Preliminary Observation Notes

1872 Vicksburg & Brunswick Railroad Depot

Adaptive-Use Renovation for First Methodist Church Building

Harvie P. Jones, F.A.I.A.

TYPICAL FRZ. DOOR
(N. DOOR, EAST MOST)

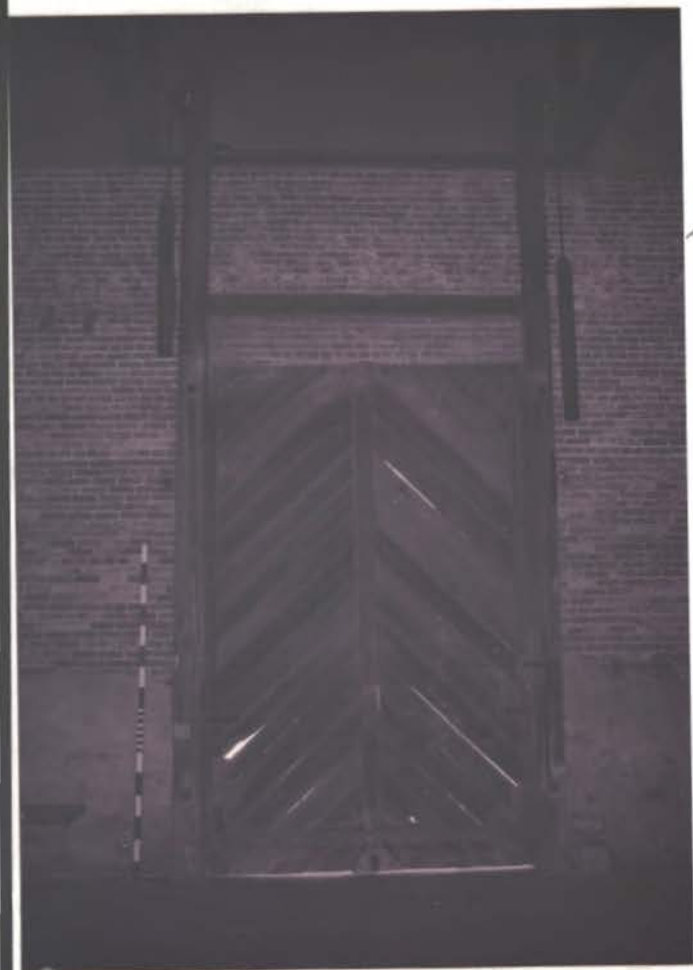
counterwt'd door
slide up

Soft →
underlight
brick &
detenir.
lime mortar

mod.
cam.
padding

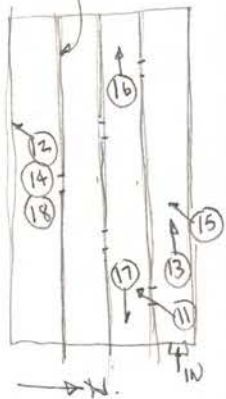
heavy dusting
from deterior.
brick mortar

negligible wood
deterior.
observable

modern props
 under
 improperly
 placed modern
 str. plat. at
 west end of
 Ext. rm.

deterior-
 brick &
 mortar at
 S. extremity
 below grade
 + above
